MINISTERIO DA MARINHA  
RECCÃO GERAL DA MARINHA  
RECCÃO DA MARINHA MERCANTE  
2ª. REPARTIÇÃO

Lisbon 26th September, 1932

FREEBOARD REPORT S.S."ANGOLA"

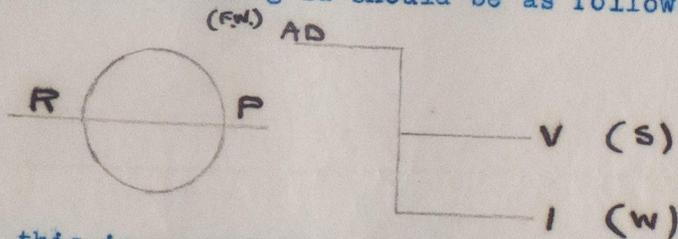
- 1) There is a slight mistake in the calculation of the Depth for freeboard, because either the thickness of the stringer plate is added, or  $\frac{T(L-S)}{1}$  when the value given by this expression is greater than the thickness of the stringer plate.
- 2) It is understood that effectively there is no allowance for tropical water, on account of the side lights which are at 25'4", but the omission of the winter freeboard mark is not justified.
- 3) The marks on the grid should be as follows:-

*As the freeboard had not been fixed by side light summer beam which would have been greater than the freeboard allowance  
No amendment*
